Addendum No. 2

Project No.: 21046

Project: **Courtice Mixed Use Seniors Development at 1697 Highway # 2
RH GAY HOLDINGS COMPANY**

The following information supplements and/or supersedes the bid documents issued on September 10 2024

DRAWING:
**WOOD STUD SHEAR WALL
ELEVATIONS**

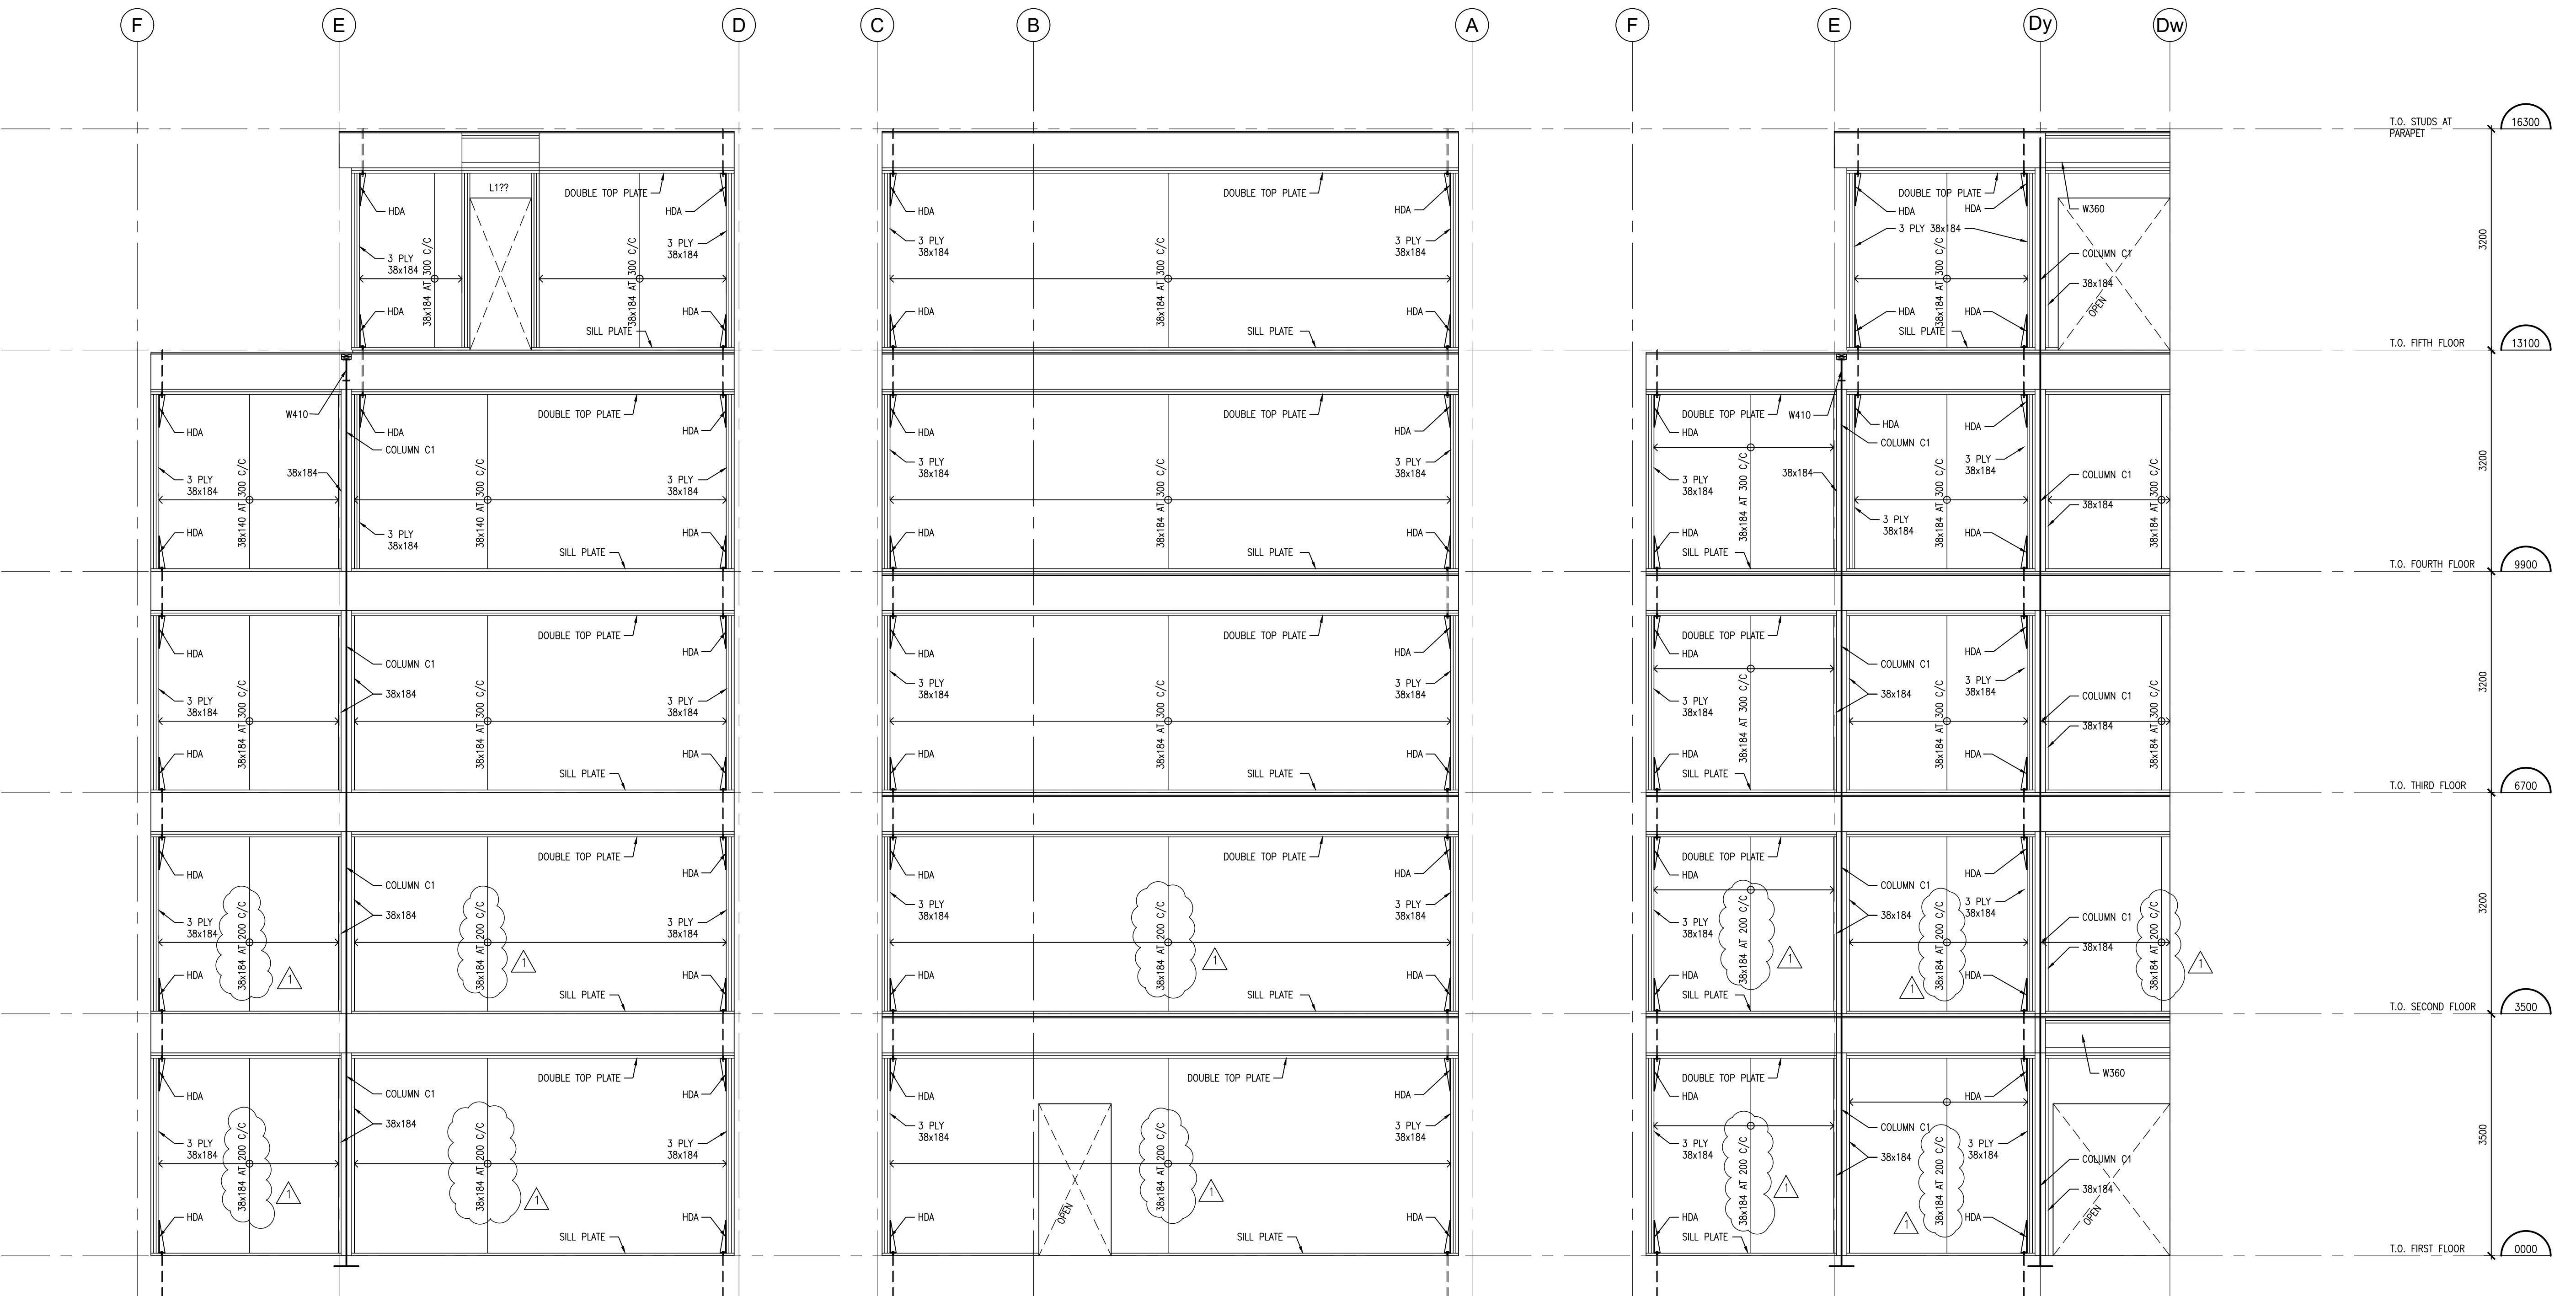
- .1 ST4 shear wall details tagged on first and second floor elevations. Refer to BBA Drawing No. S305 dated September 3, 2024.

DRAWING:
**WOOD STUD SHEAR WALL
ELEVATIONS**

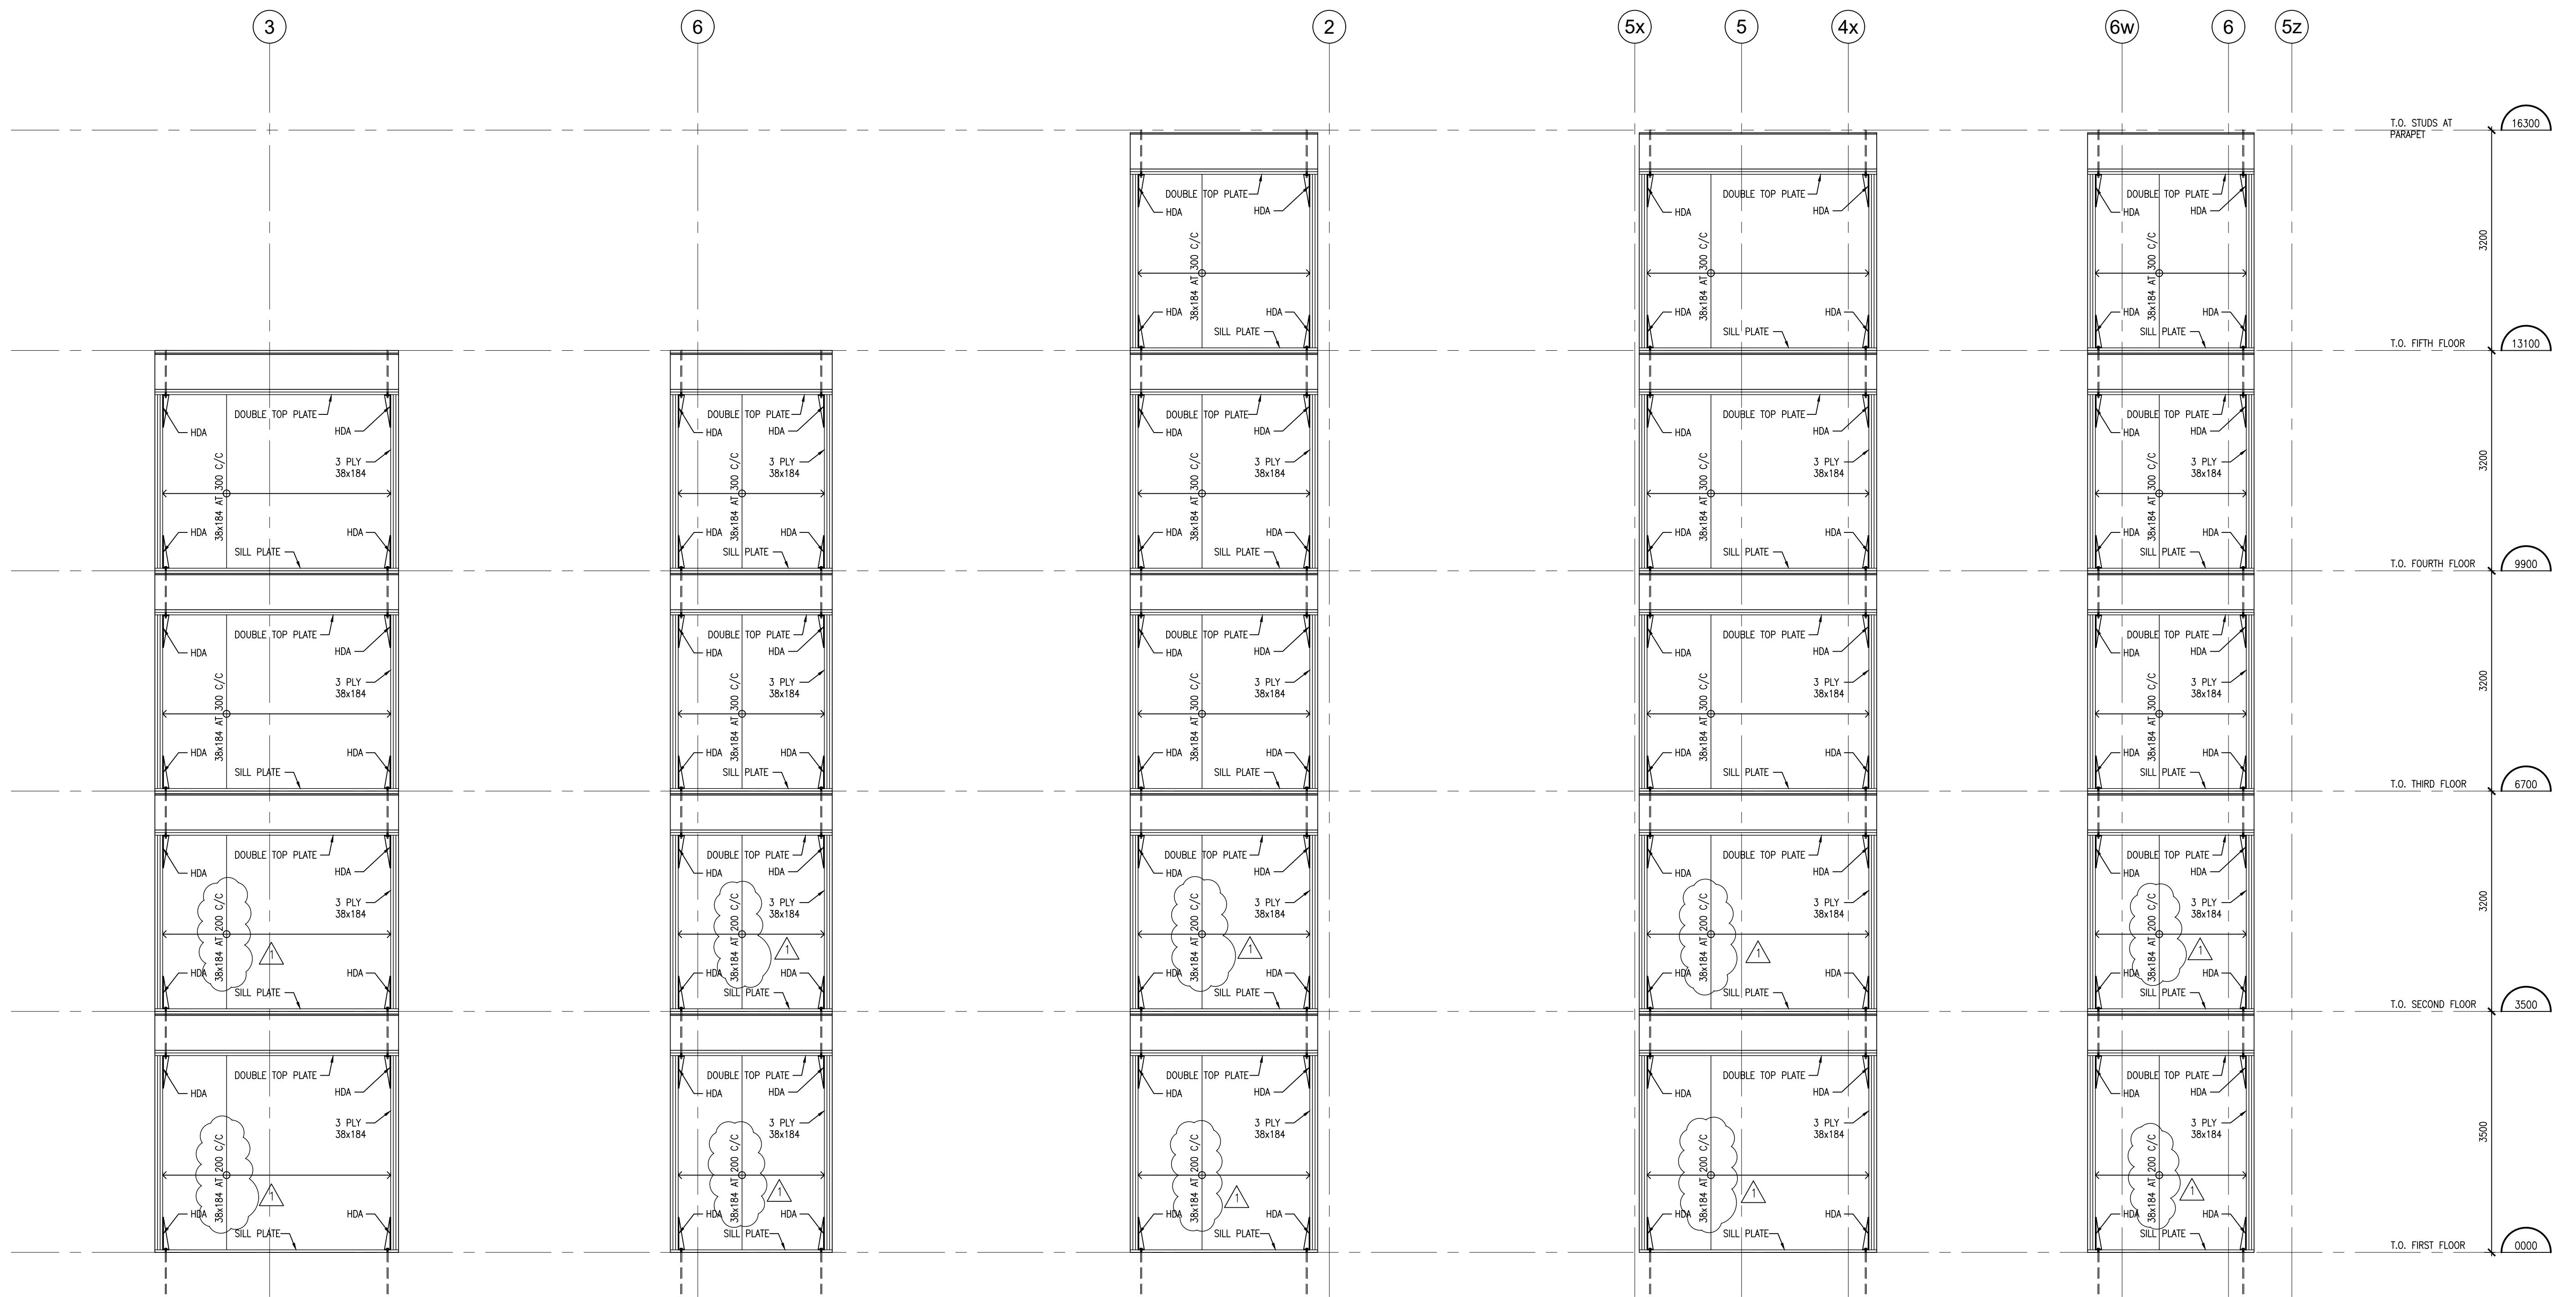
- .1 ST4 shear wall details tagged on first and second floor elevations. Refer to BBA Drawing No. S307 dated September 3, 2024.
